RE: **Argonne St Residences Comment Responses**
Case Number: 2003-4008-04

ARGONNE RESIDENCES

BE COMMENT
RESPONSES
05/11/21

SITE PLAN AMENDMENT
ARGONNE STREET RESIDENCES
1511, 1521, 1534, AND 1541 ARGONNE STREET
AURORA, CO 80011
JESSE DONOVAN, P.E. 720-504-8629

GRADING PLAN

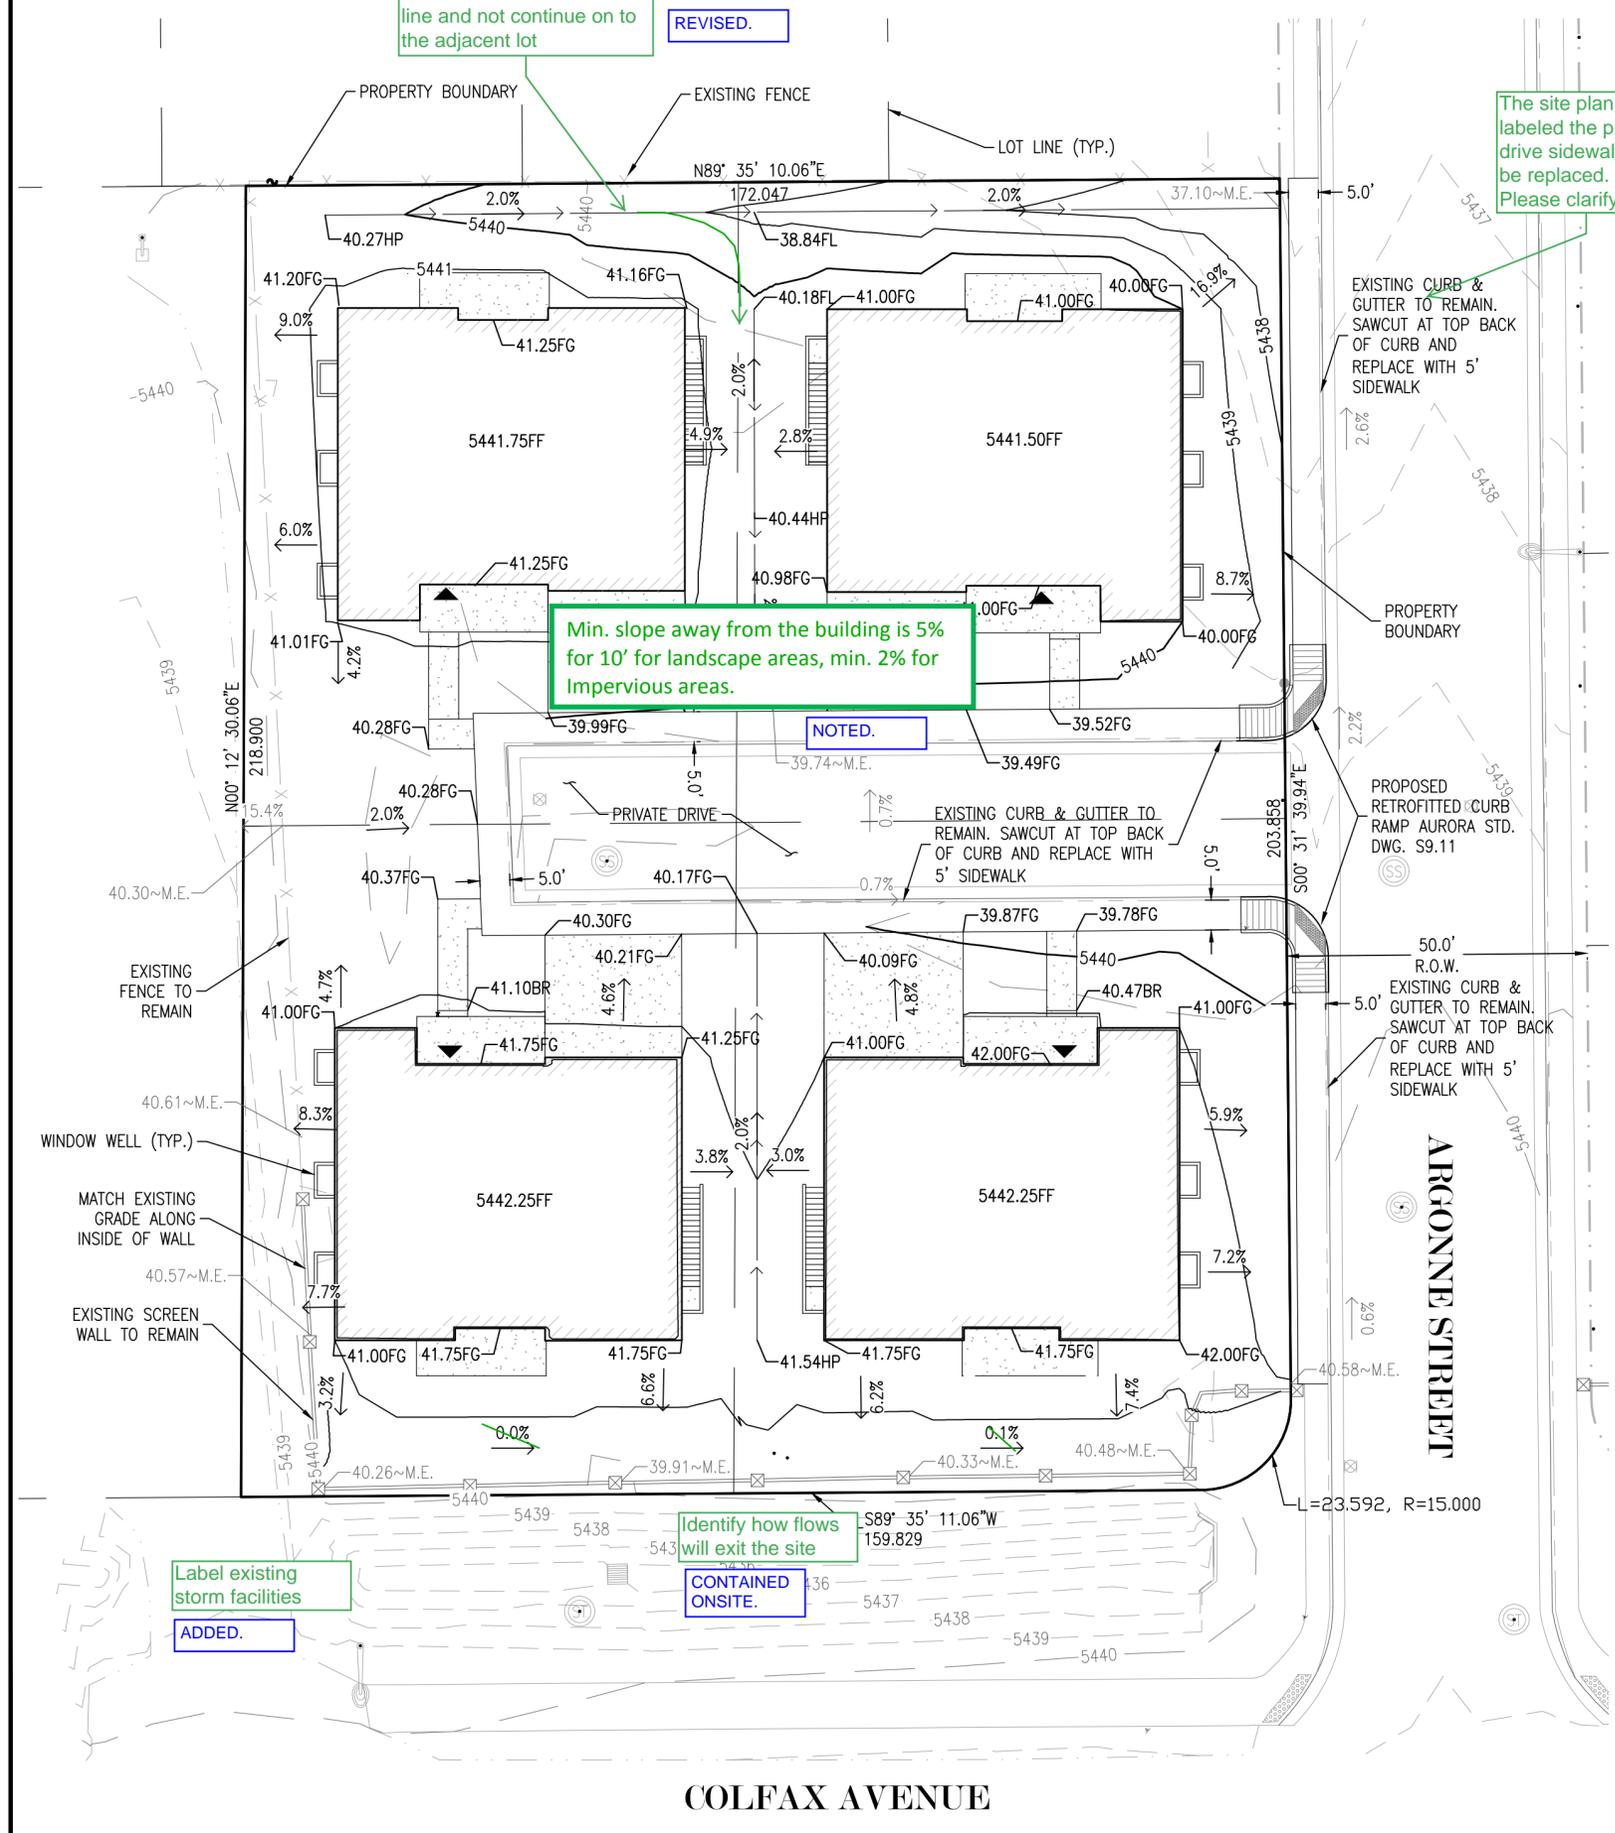
The flows from this rear yard need to be directed to a swale down the side lot line and not continue on to the adjacent lot

The site plan only labeled the private drive sidewalk to be replaced. Please clarify

Min. slope away from the building is 5% for 10' for landscape areas, min. 2% for impervious areas.

Label existing storm facilities

Identify how flows will exit the site

REVISED.

REVISED.

NOTED.

ADDED.

CONTAINED ONSITE.

UTILITY PLAN

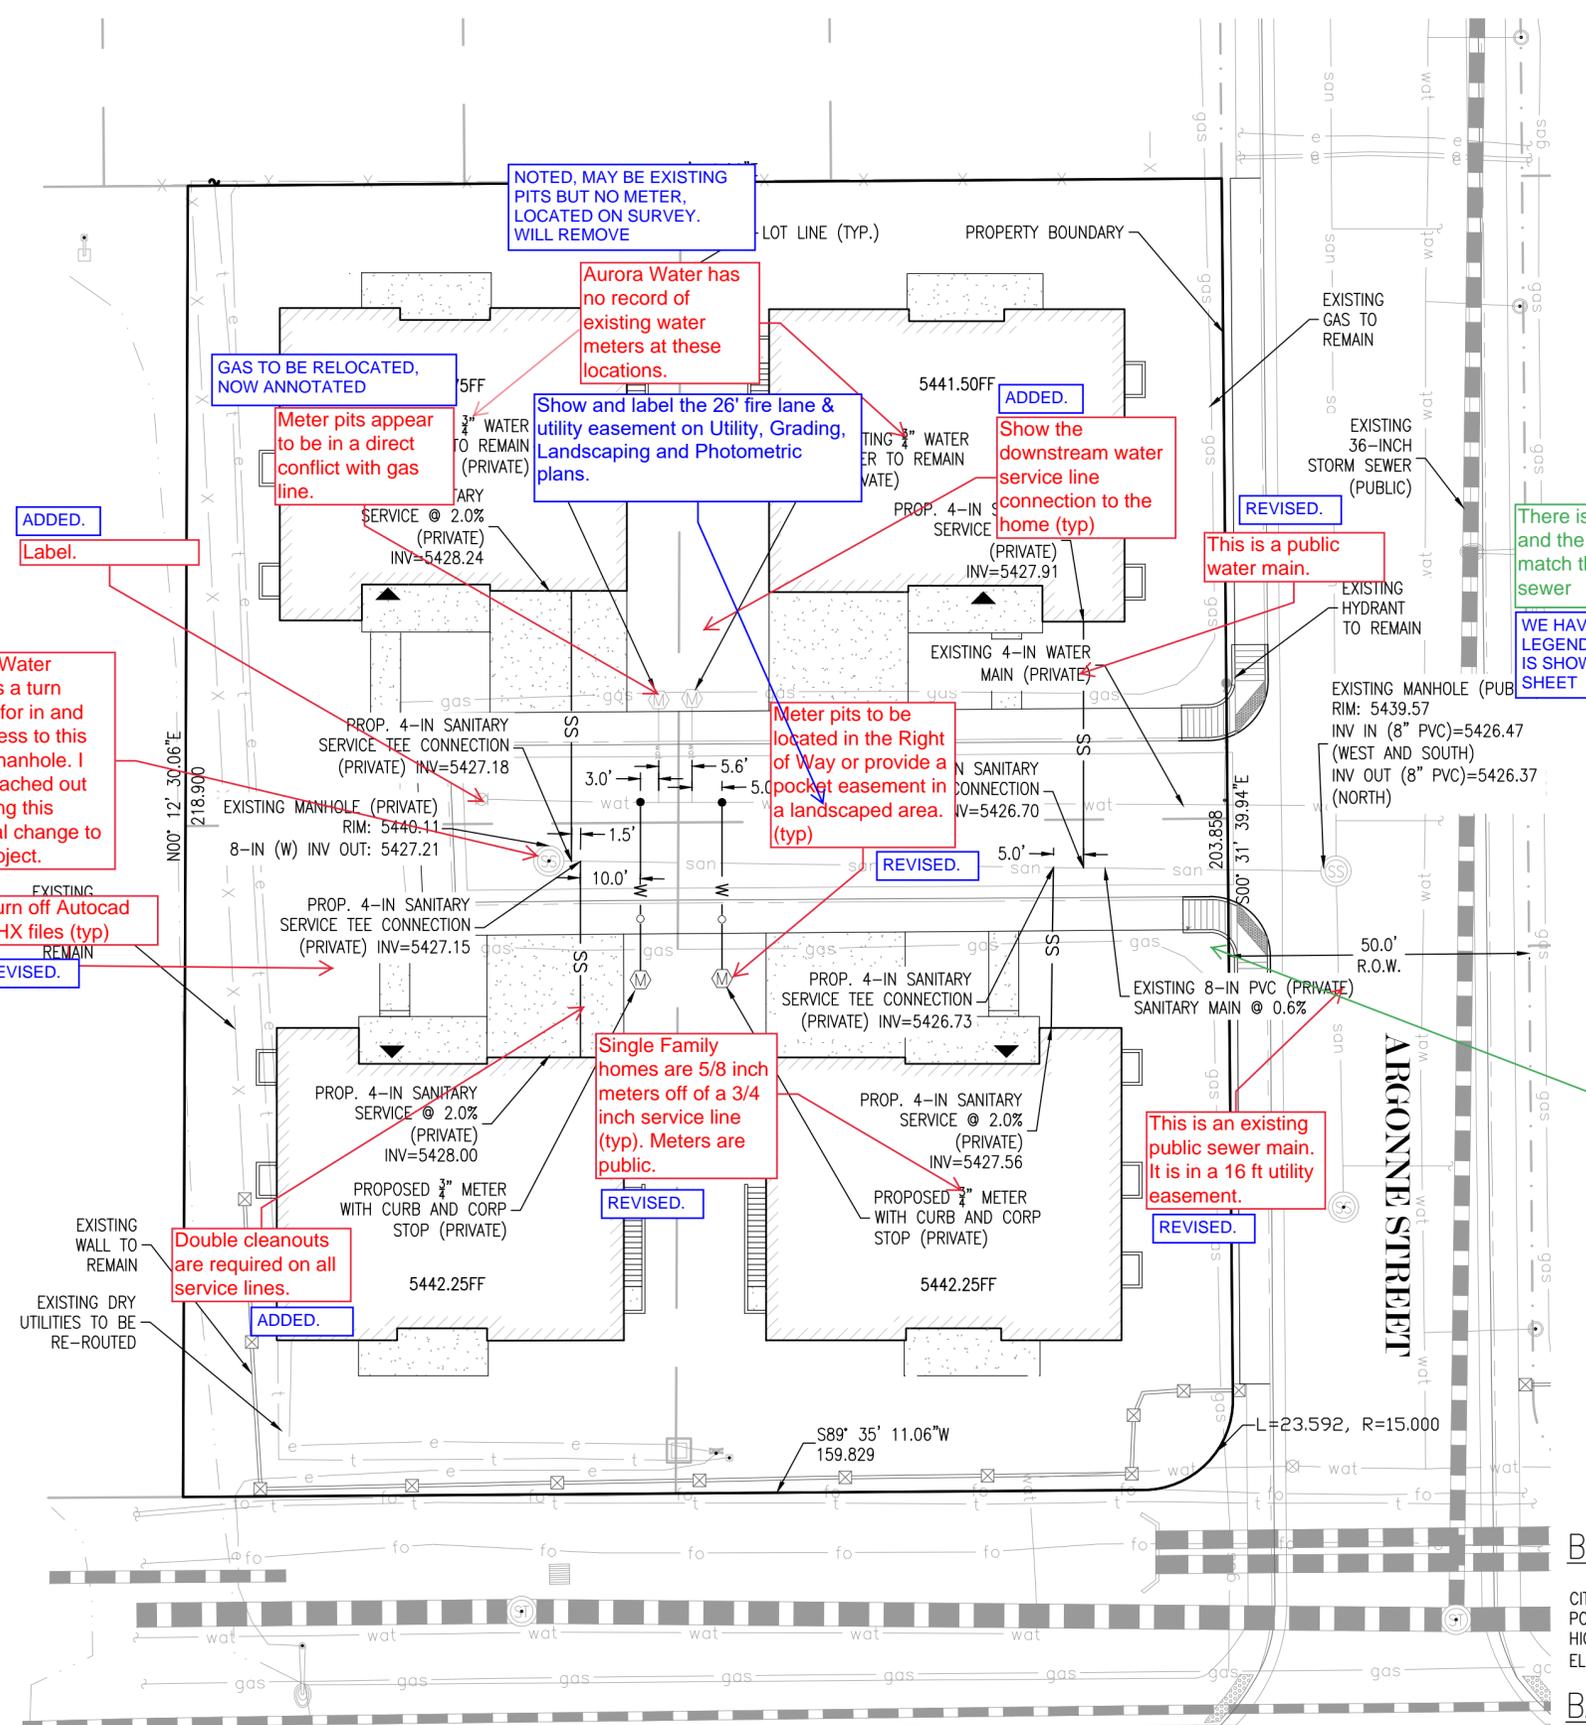
Aurora Water requires a turn around for in and out access to this public manhole. I have reached out regarding this potential change to your project.

Double cleanouts are required on all service lines.

Aurora Water has no record of existing water meters at these locations.

Show and label the 26' fire lane & utility easement on Utility, Grading, Landscaping and Photometric plans.

Show the downstream water service line connection to the home (typ)

This is a public water main.

There is no proposed storm and the line type does not match the existing storm sewer

Meter pits to be located in the Right of Way or provide a pocket easement in a landscaped area. (typ)

This is an existing public sewer main. It is in a 16 ft utility easement.

Show proposed street light

THIS PRIVATE ACCESS DRIVE MEETS FIRE CODE FOR 150-FT BACKOUT DISTANCE FOR A FIRE APPARTUS VEHICLE. DOES AURORA WATER HAVE A MAXIMUM BACKOUT REQUIREMENT, IF SO PLEASE CITE.

NOTED, MAY BE EXISTING PITS BUT NO METER, LOCATED ON SURVEY. WILL REMOVE

WE HAVE REVISED THE LEGEND TO REFLECT WHAT IS SHOWN ON THIS PLAN SHEET

THERE IS A MIDBLOCK STREET LIGHT, ACROSS STREET, NOW ANNOTATED. IS THIS REQUIRED? PLEASE CITE CODE
